Submittal

High Purity RO/DI Water Skid

Job Number: S-100516001

Shop Drawing Submittal Review

SJE PUMPMASTER® SPDT Pump Switch

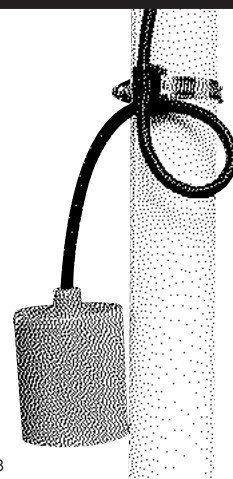
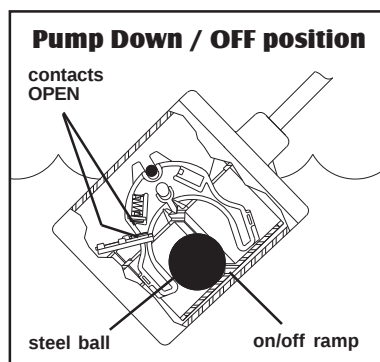
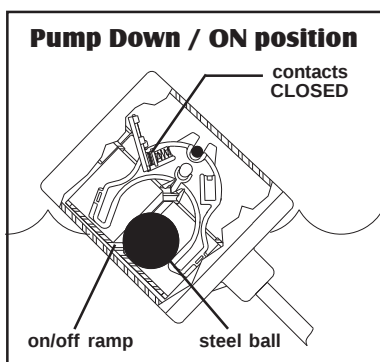
Verify electrical rating of SPDT switch is compatible with electrical characteristics of

Yes. Compatible with PLC. Used as a low voltage control circuit.
